CITY OF ALBUQUERQUE

RE: **Lot 3 Block 12 Volcano Cliffs Unit 24 SAD 227**
6208 Marigold Dr. NW
Grading and Drainage Plan
Engineers Stamp Date 9/20/2021 (E10D111)
Pad Certification Date 5/13/2022

DRAINAGE AND TRANSPORTATION INFORMATION SHEET (REV 6/2018)

ENGINEER'S SEAL 9/20/21 DAVID SOULE P.E. #14522	6208 MARIGOLD	DRAWN BY: WCVJ DATE: 9-17-21 210210085-LAYOUT-9-18-21
	GRADING AND DRAINAGE PLAN	SHEET #
	 Rio Grande Engineering 1606 CENTRAL AVENUE SE SUITE 201 ALBUQUERQUE, NM 87106 (505) 872-0999	JOB # 210210085

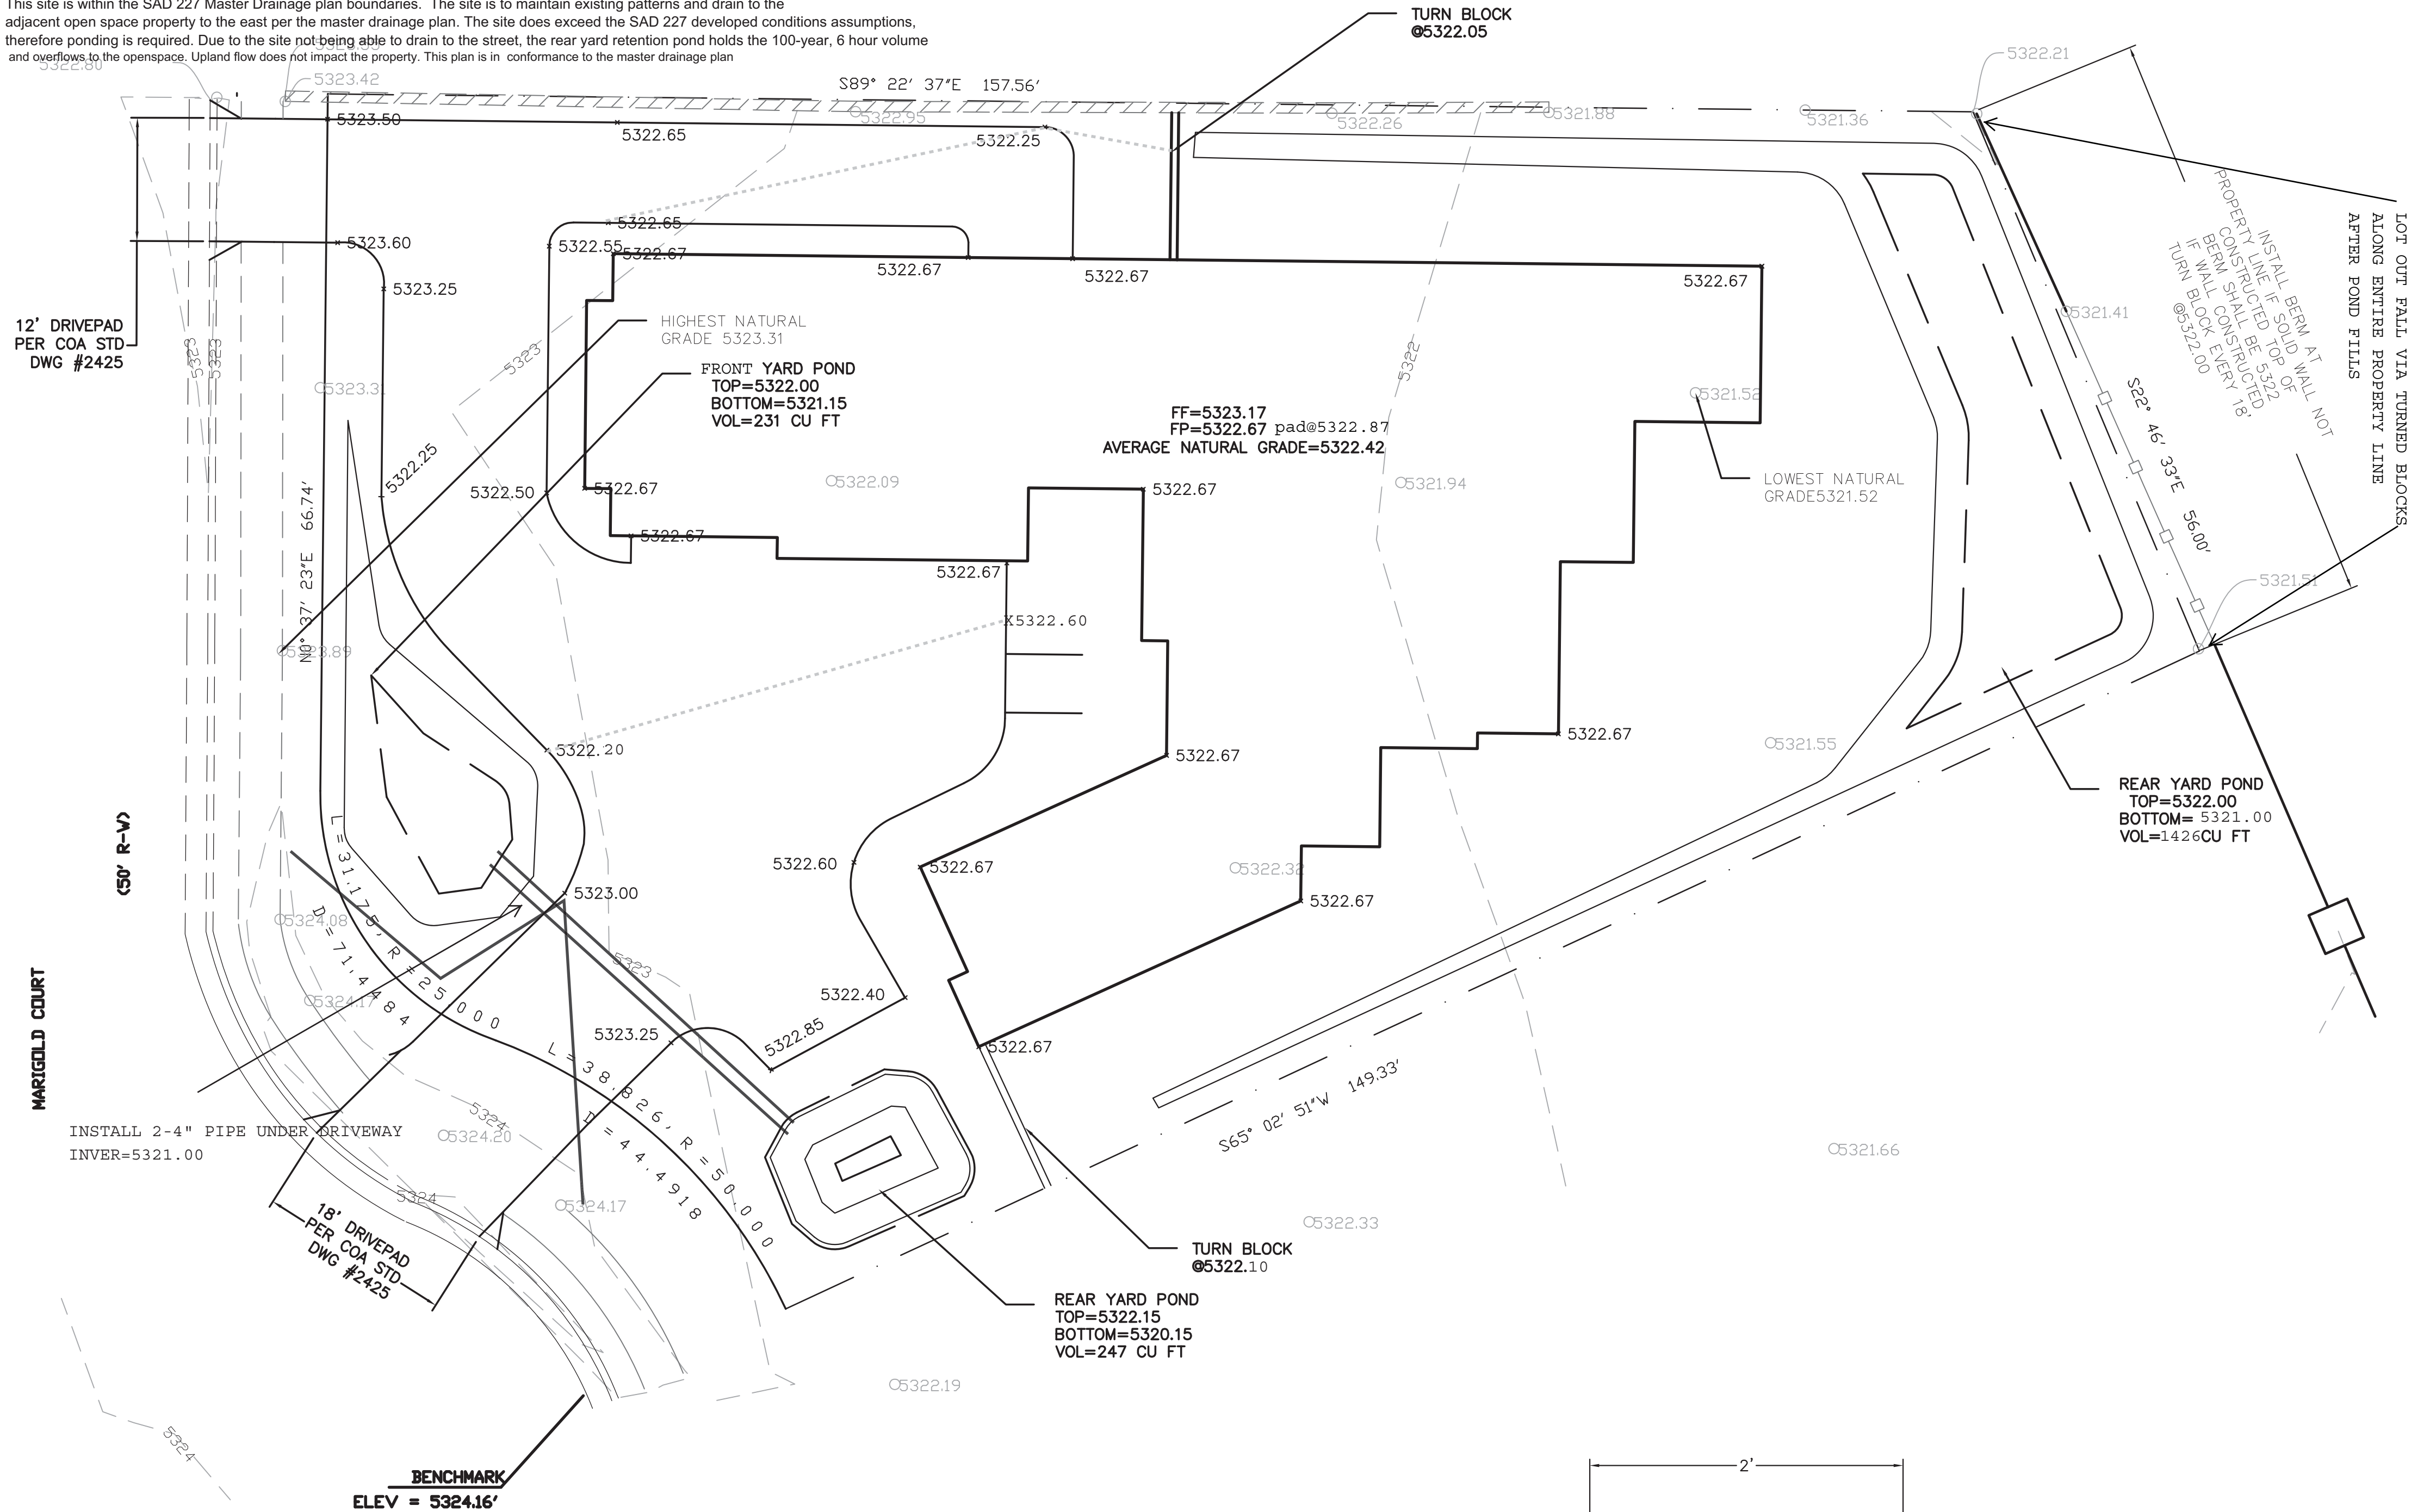
Based upon the information provided in your submittal received 5/16/2022, this plan is approved for Building Permit.

Reiterate to the Owner/Contractor that a separate permit for a garden/retaining wall must be obtained, with the approved G&D plan and Pad Certification. Also, let the owner/contractor know that if a pool is to be added in the future the G&D plan will need to be modified showing the location of the pool and the land treatment differences. Also advise the owner & Contractor that dirt is not allowed in the public right of way to climb the curb. Crusher fines or lumber is allowed. If dirt is used this will delay going forward with the construction of the home.

Prior to Certificate of Occupancy release, Engineer Certification per the DPM checklist of this plan will be required.
